# ANN ARBOR BUILDING BOARD OF APPEALS

## STAFF REPORT

Building Board of Appeals Request **BBA18-004** at 211 W. Davis, ANN ARBOR, MI 48104.

### **Code Summary of Conditions, Interpretation, Staff Recommendation**

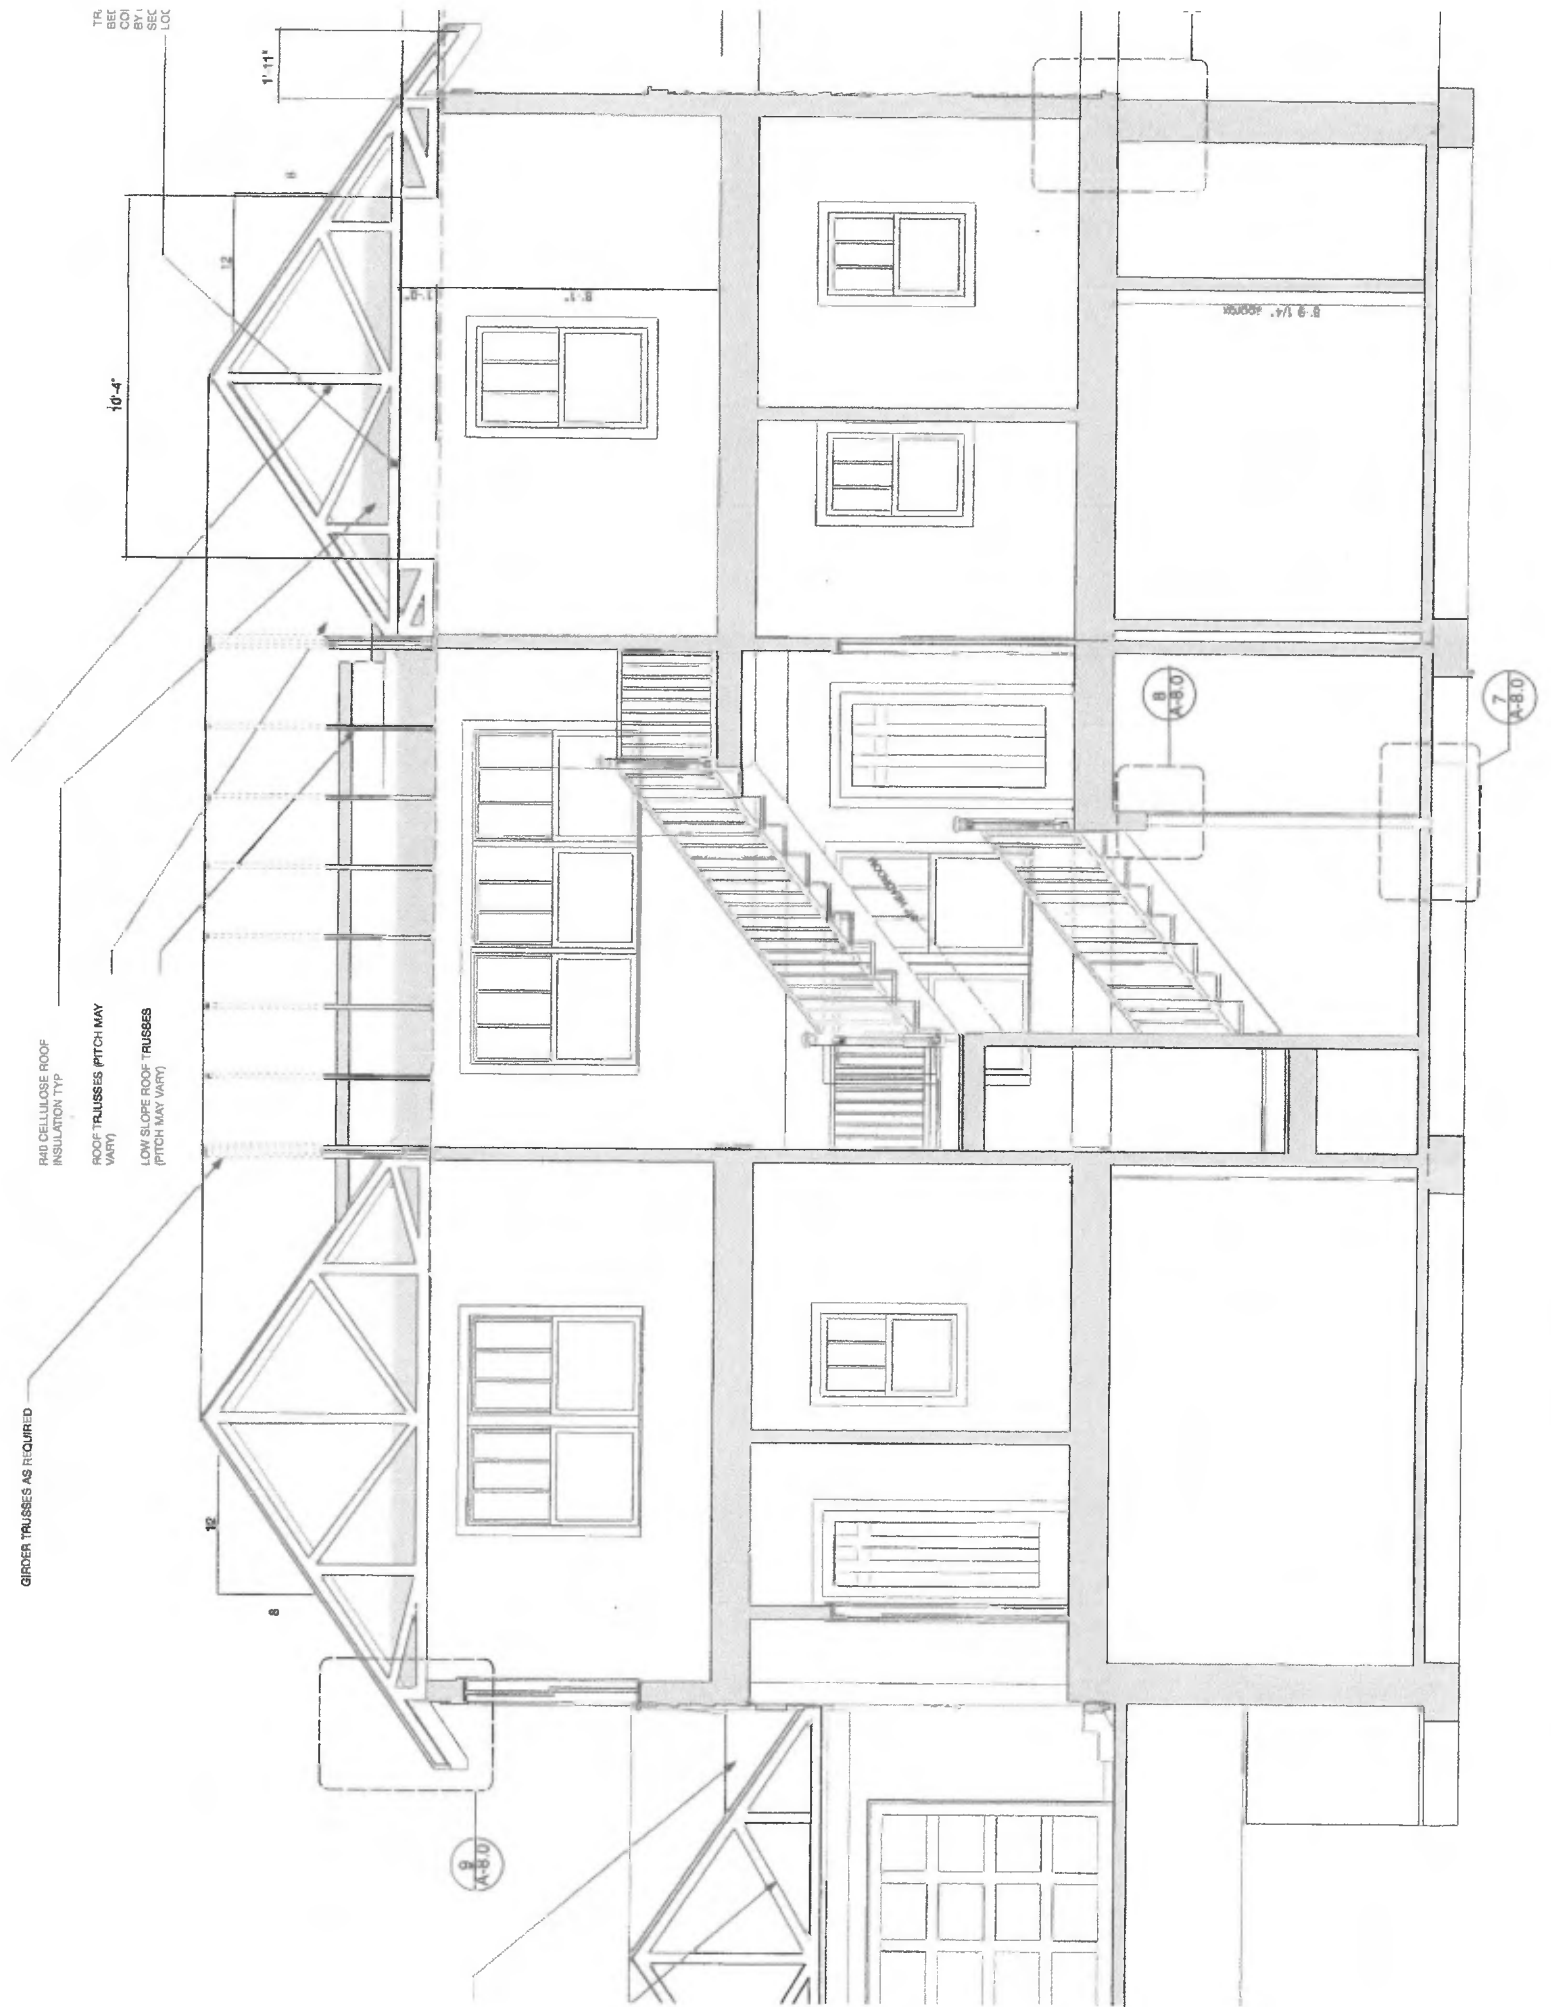
The condition arose from a differing interpretation of the building code that was identified during plan review. The small lot (4865 sq ft) was granted setback variances based upon the previously existing footprint. The west side-yard setback was established at 1'-5".

The new single-family residence's attached garage was set back from the side lot 2'0" with a 12" overhang. MRBC Table R302.1 (1) was interpreted to allow projections into the wall setback if the wall was at least 2' from the lot line. While the MBC has a separate table for projections, the MRBC places projections under the table for walls. This interpretation would allow for an eave projection if the soffit was fire rated and blocking installed between the roof sheeting and top plate. The building official disagreed with this interpretation.

A mitigating factor is the adjacent property to the west, a multifamily townhouse project developed under the conflicting land use provisions of the R4C zoning district. This measure establishes a permanent 15 ft setback from adjacent residential properties. This 15 ft plus the 2' setback on the subject property would create a 17 ft building separation or in effect an 8'6" fire separation distance. Within this setback no structures, trellises, accessory buildings or patios are allowed. Only green landscaping is permitted.

As a further measure of public safety, the builder has proposed to put a 2-hour rating assembly to the west wall of the garage that is near the lot line, a 1-hour rating to ceiling and a 1-hour rating to house/garage separation. See Attached 2-hour assembly.
